**PART 573 Defect and Noncompliance Report**

Report Date: 4-19-2010

<b>Make:</b>	Wildcat	<b>Model Years Involved:</b>	2004 - 2009	
<b>Model(s):</b>	510, 510LT			
<b>Production Dates:</b>	<b>Beginning:</b>	04-08-2004	<b>Ending:</b>	12-31-2009
<b>VIN Range:</b>	<b>Beginning:</b>	1W9SS26274F351262	<b>Ending:</b>	1W98261A39F351716
<b>Vehicle Type:</b>	Trailer - Single axle trommel screen

EXHIBIT A  
TONGUE ASSEMBLY  
WC-20070

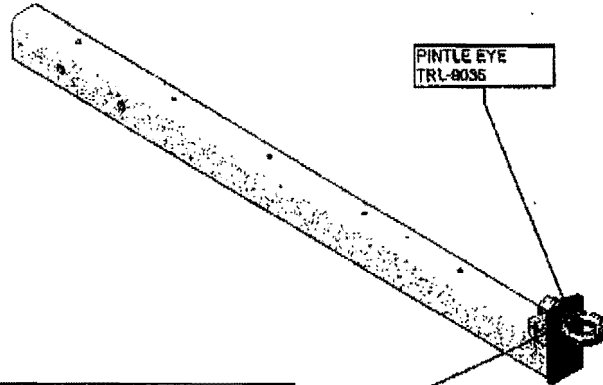
Model 510 units, with serial numbers between 351262 - 351716, and Model 510LT, with serial numbers between 351527 - 351705, were equipped with an adjustable length tongue assembly, item number WC-20070 (Exhibit A). The pintle eye (Item number TRL-9035) used in the tongue assembly does not have an adequate vertical or horizontal load rating for the gross weight of the vehicle.

The pintle eye on the hitch was incorrectly sized for the gross weight of the vehicle

The pintle eye could fail resulting in separation of the tongue from the tow vehicle. Complete separation from the tow vehicle is prevented by the dual safety chains.

- (a) Visible cracking of the pintle eye at the transition of the eye loop to the shaft that attaches the eye to the tongue.

Engineering has specified a larger pintle eye that has an adequate load rating to support the machine tongue weight and handle the horizontal force from the vehicle.

Field kit modifications are currently under development. The new pintle eye load rating is sufficient to handle both the vertical and horizontal forces from the vehicle.

The tongue assembly was redesigned to allow the use of the new pintle eye in January, 2010.

FIELD KIT WILL MODIFY THE MOUNTING PLATE ON  
THE FRONT END OF THE EXISTING TONGUE  
ASSEMBLY AND A LARGER CAPACITY PINTLE EYE  
WILL REPLACE THE EXISTING EYE
